Notice of Allowability

10/685,274

EXAMINER'S AMENDMENT

FIG. 7

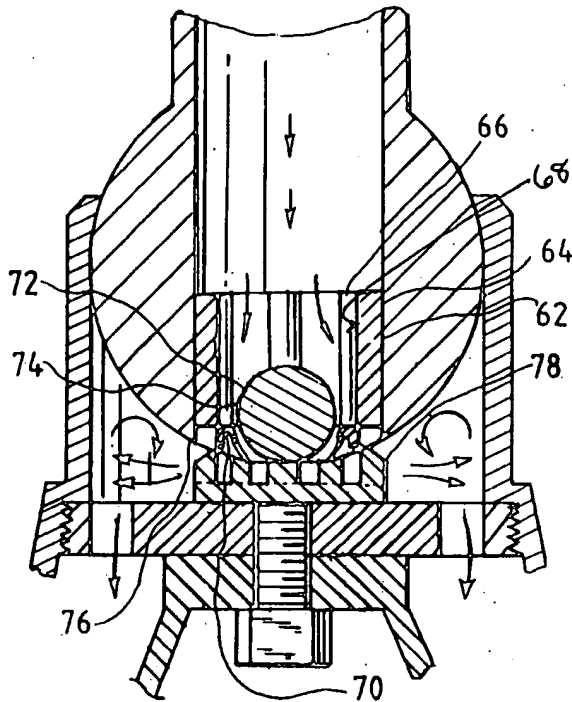
- Figures 7 and 8 must include reference number "68", which designates the inner circumferential surface of the valve body as disclosed on page 11 of the specification.

Please refer to the enclosed marked-up page 3 of 3, which indicates in red ink where reference number "68" should be located in Figures 7 and 8 of Applicant's Replacement Sheet.
